MIL On With DTC(s) P060649 and/or P060647

Service Category Vehicle Interior

YEAR(S)	MODEL(S)	ADDITIONAL INFORMATION
2023	Sequoia HV	
2022 - 2023	Tundra HV

Figure 1. Location of Authorized Modifications Label on 2022 – 2023 Tundra HV and 2023 Sequoia HV

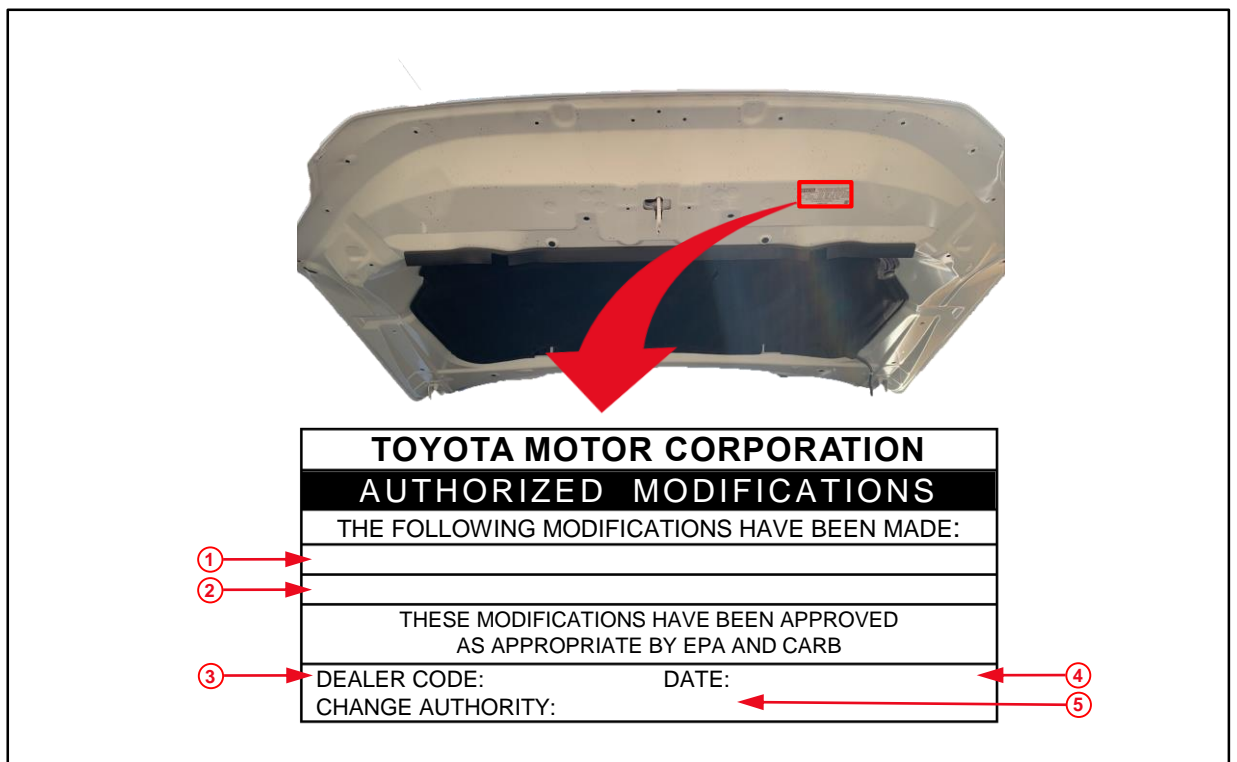
2. Use Techstream to confirm if the ECM (PCM) calibration has been updated and check for the Authorized Modifications Label affixed to the vehicle in the location shown below. Is the calibration ID listed in Techstream and on the label the latest ECM (PCM) calibration?
 - **YES** — This bulletin does NOT apply. Continue diagnosis using the applicable Repair Manual.
 - **NO** — Continue to step 3.

1	Replacement Skid Control Computer Part Number e.g., 896610CU71
2	New Calibration ID e.g., 896630CS1200
3	Dealer Code

4	Date Completed
5	This SB Number
